## ADDENDUM NO. TWO (2)

Date: 03/28/2022 Architect's Project No. A20-159

Project: IFB 22-003 Sugar Hill Historic Cemetery

Client: City of Sugar Hill

C6.1

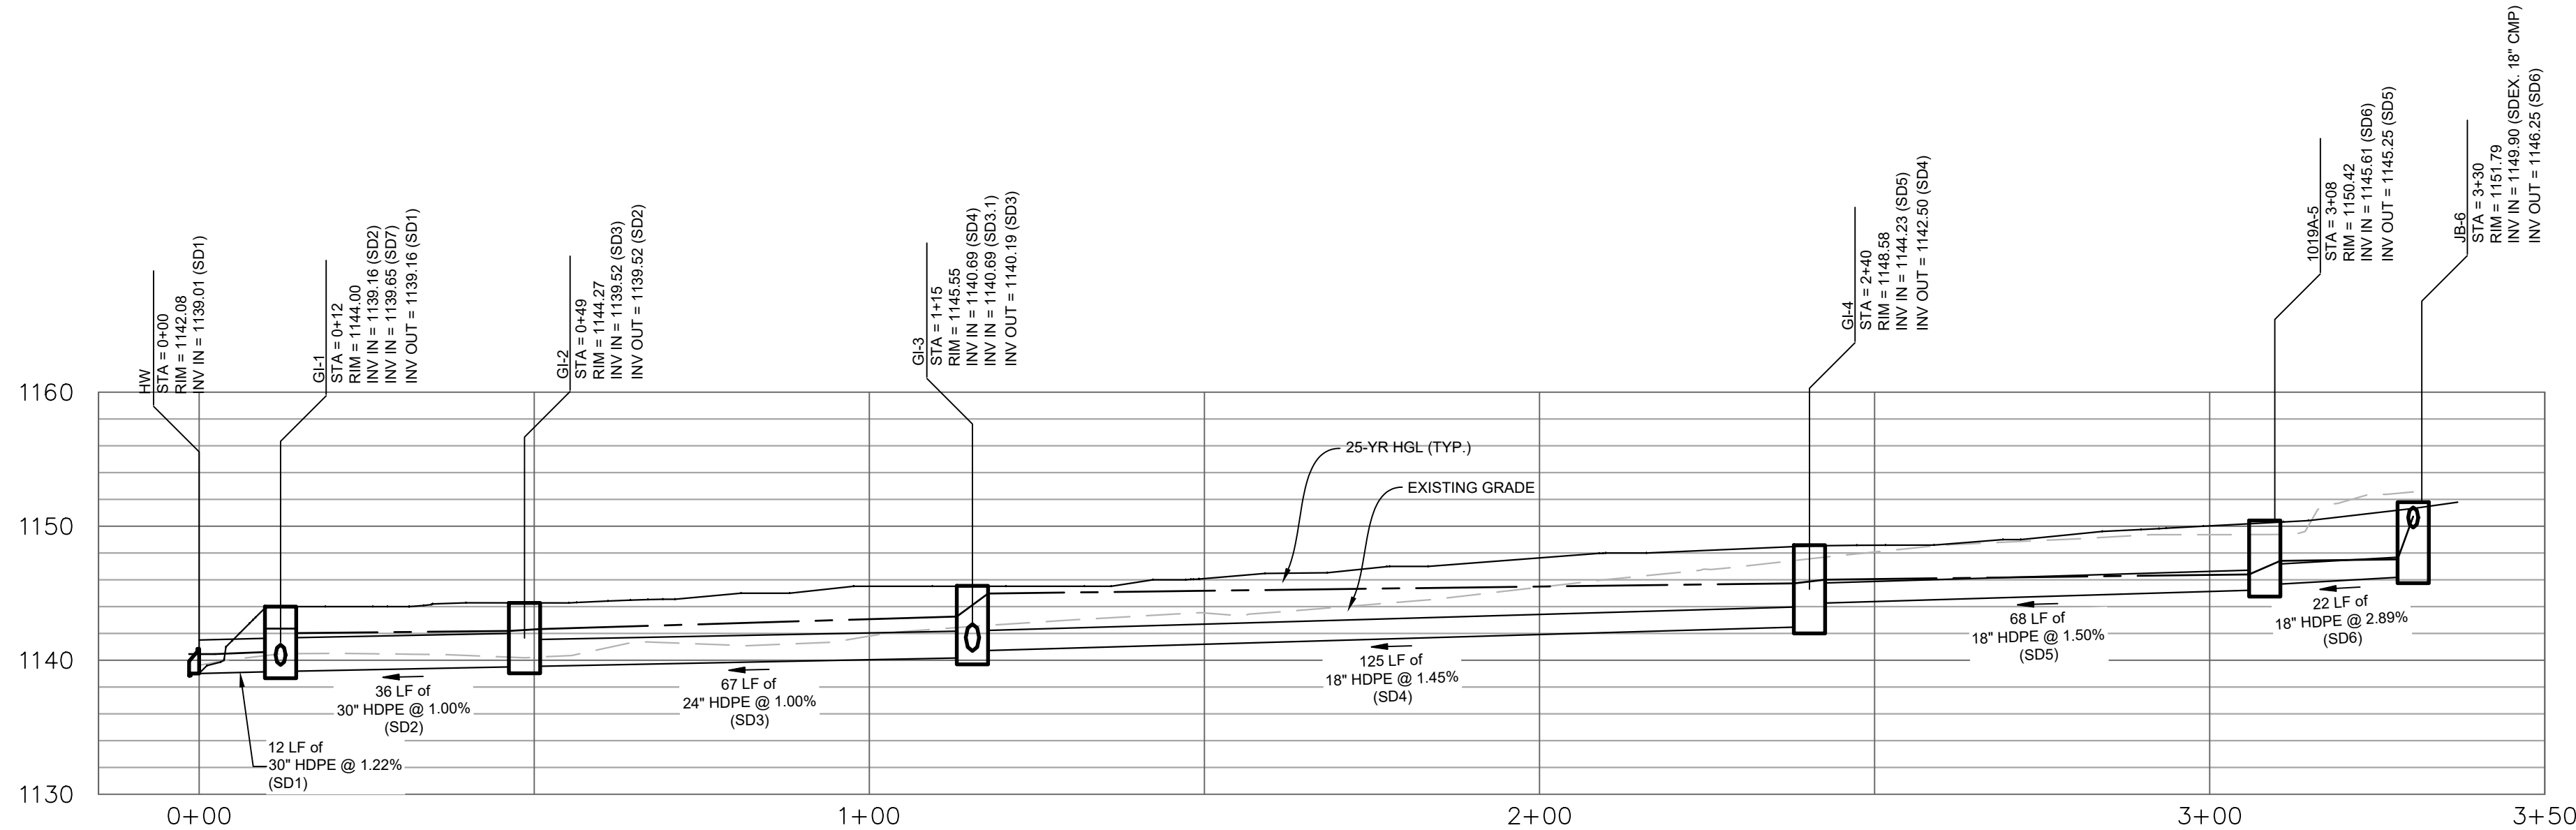
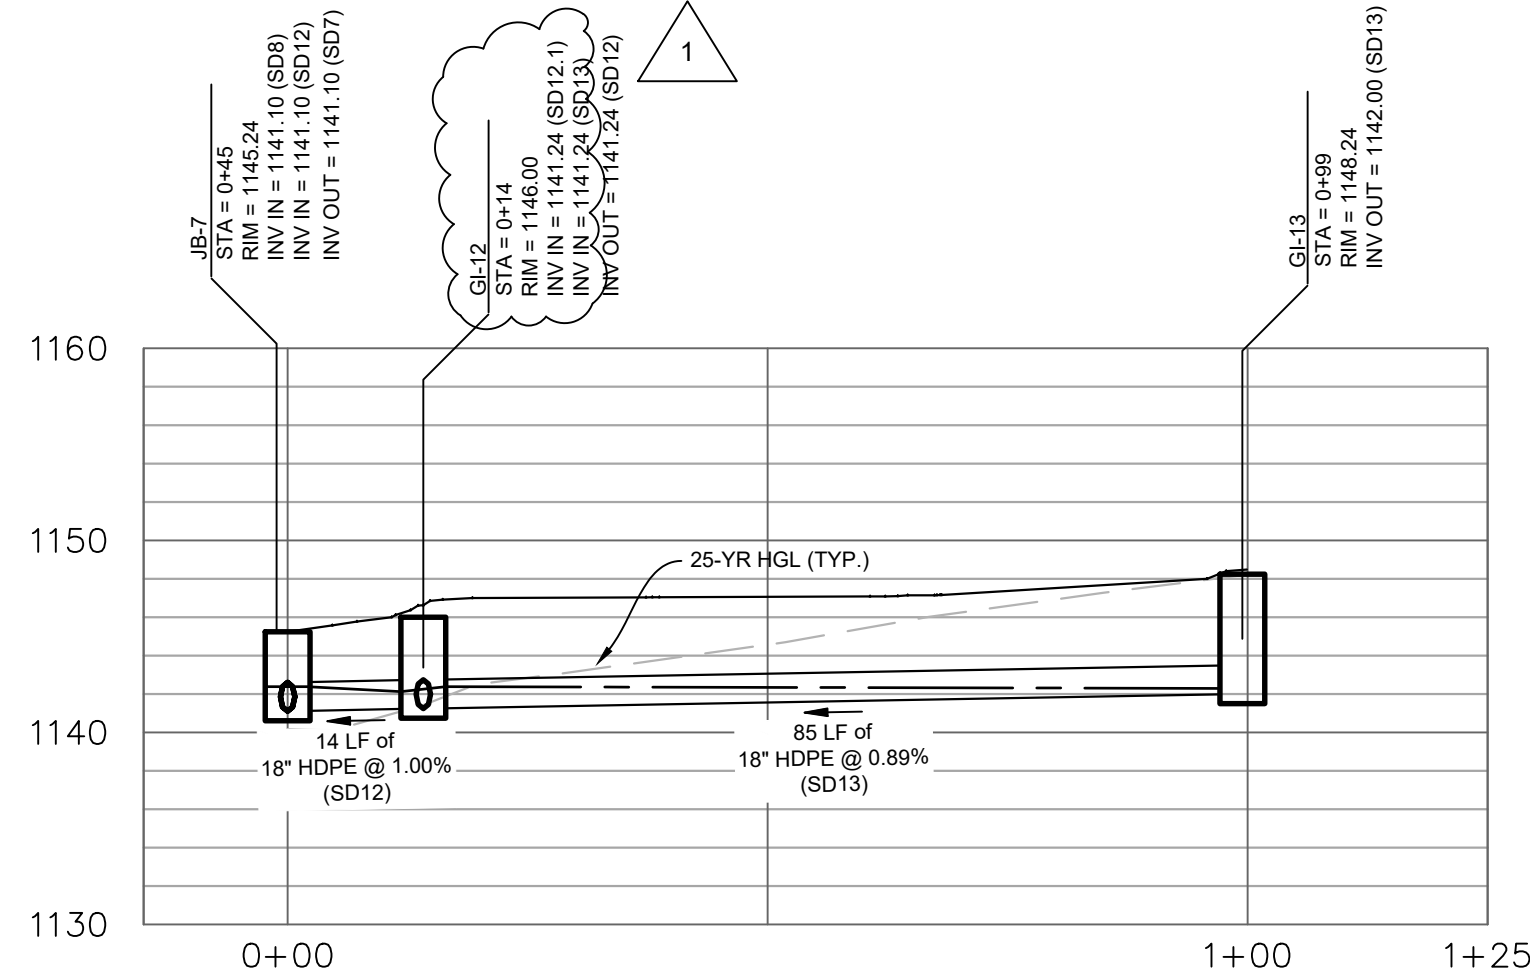
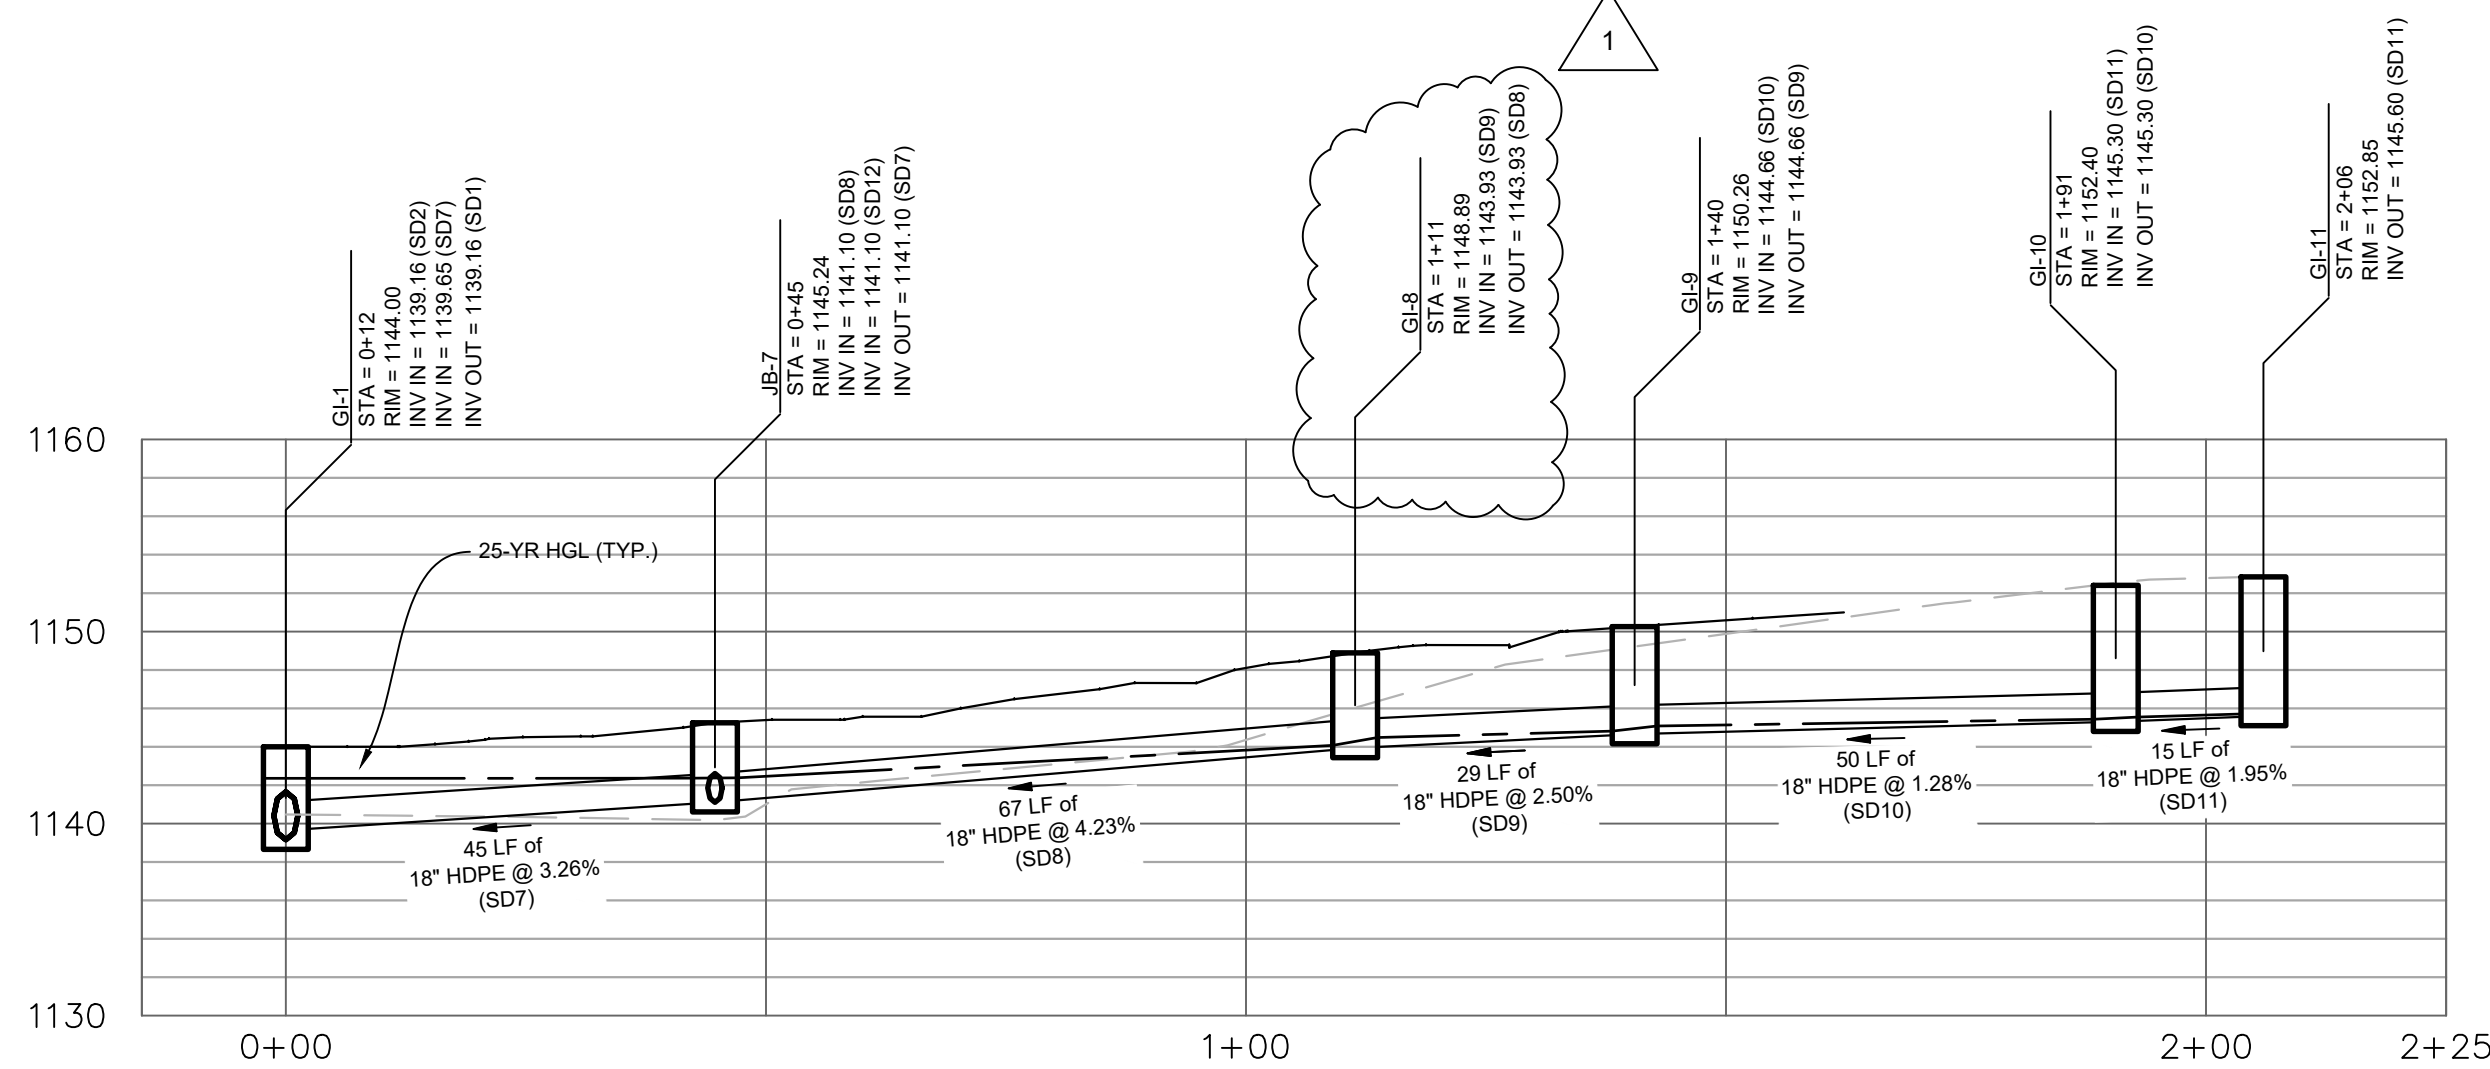
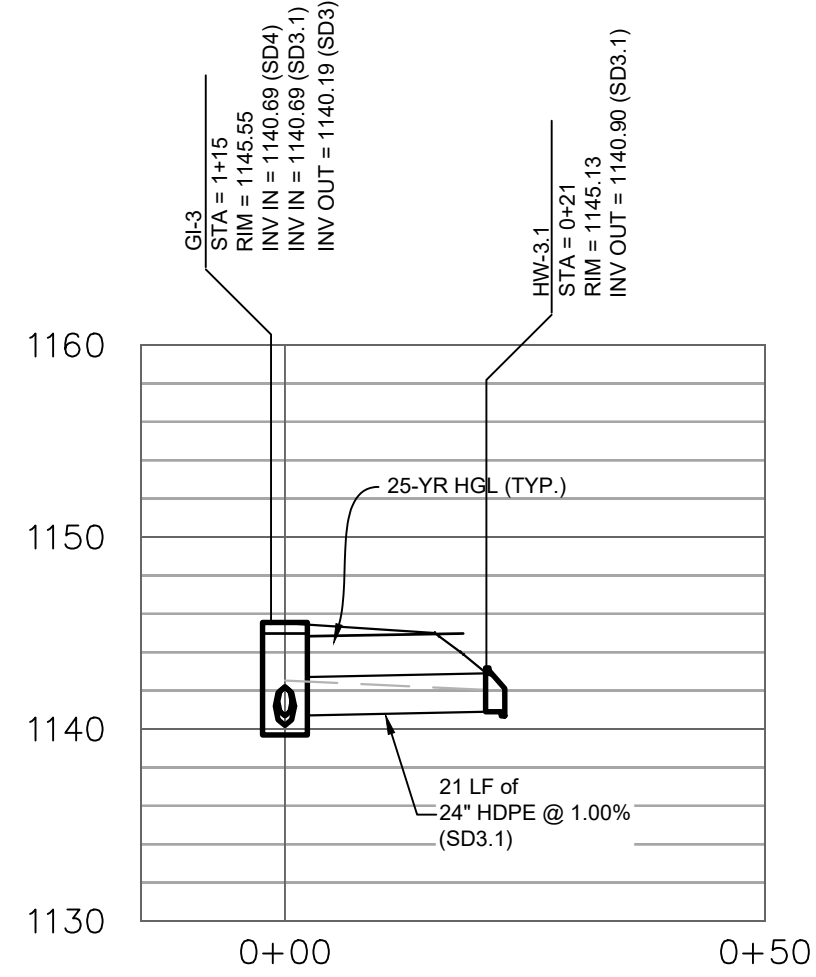
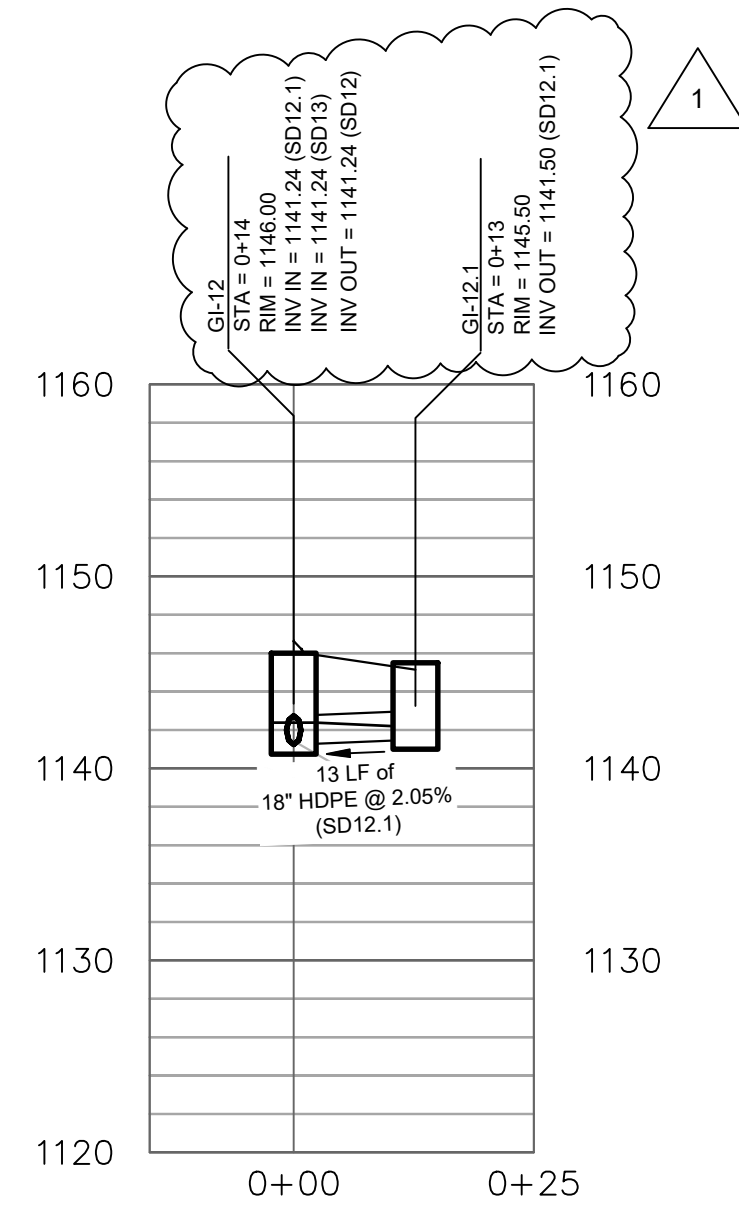
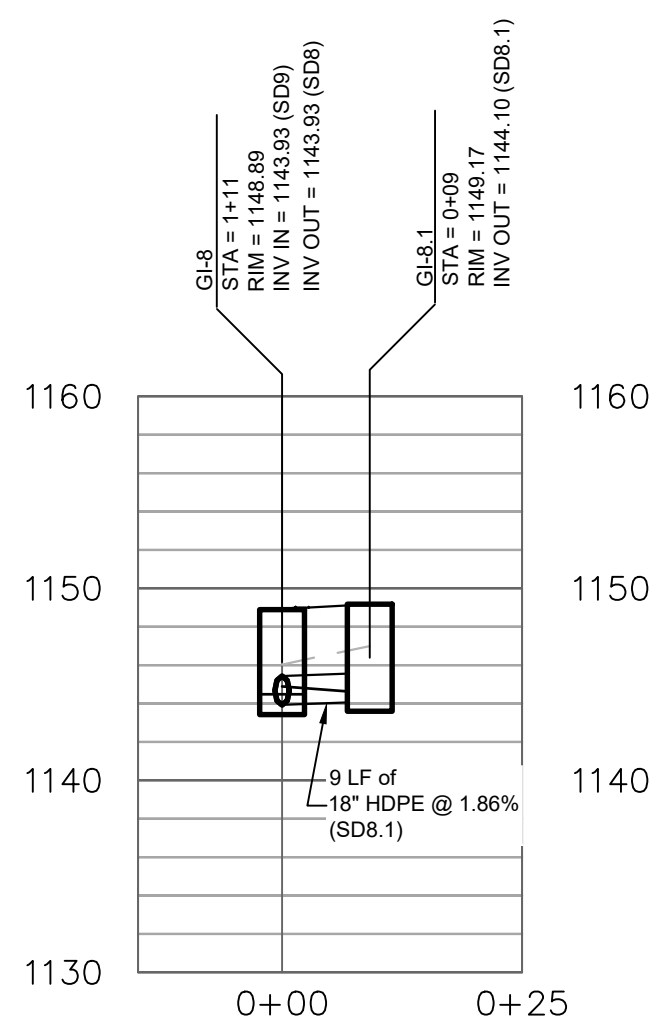
6. Revise multiple storm water pipe sizes and 25-yr storm chart. Refer to revised sheet C6.1.
